Power Systems

Service Information Letter

Letter No. A-120

Improved Air Pressure Switch - P/N 94E42

Figure 1

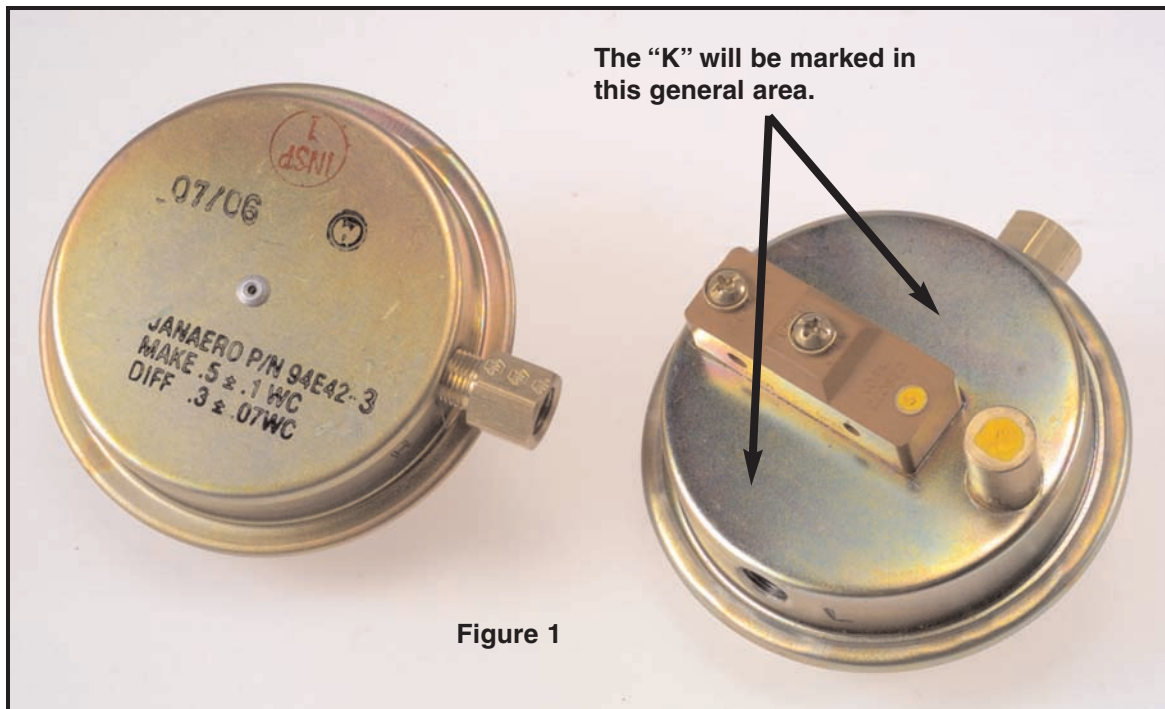
3. If replacing the air pressure switch as a product improvement, examine the switch body for an ink stamped part number which should be on the back side of the body. On the other side (switch end) look for the letter "K". If found, the product improvement has already been accomplished. See Figure 1 on page 2 of this Service Information Letter. *Note: Examination of Log Book entries may not reveal that this product improvement has been accomplished because the new air pressure switch carries the same JanAero (Janitrol) part number.*
